Product change notification (PCN)

Title / short description	Product change
Affected article category	Relay modules
Change category	Marking
Change number	CCK240038-00
Reason for PCN/PDN Revision

Old Version

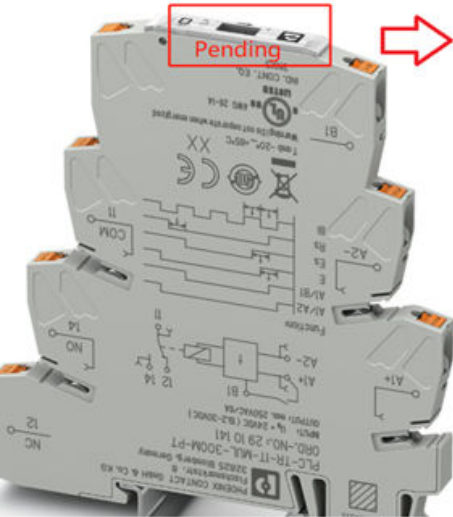
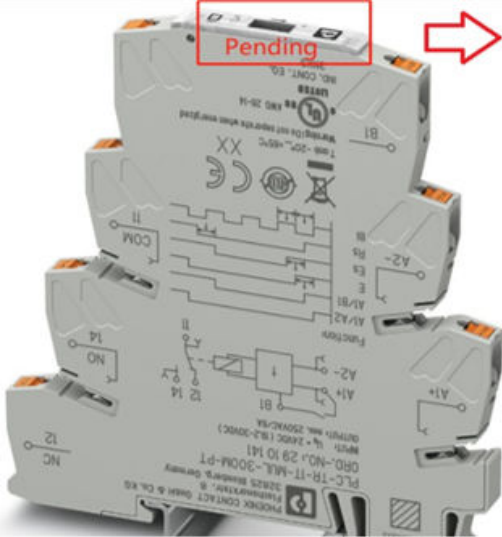
Improving the durability and abrasion resistance of printing

The printing process of the knurled wheel of the PLC timer was changed from color to laser

Printing laser process
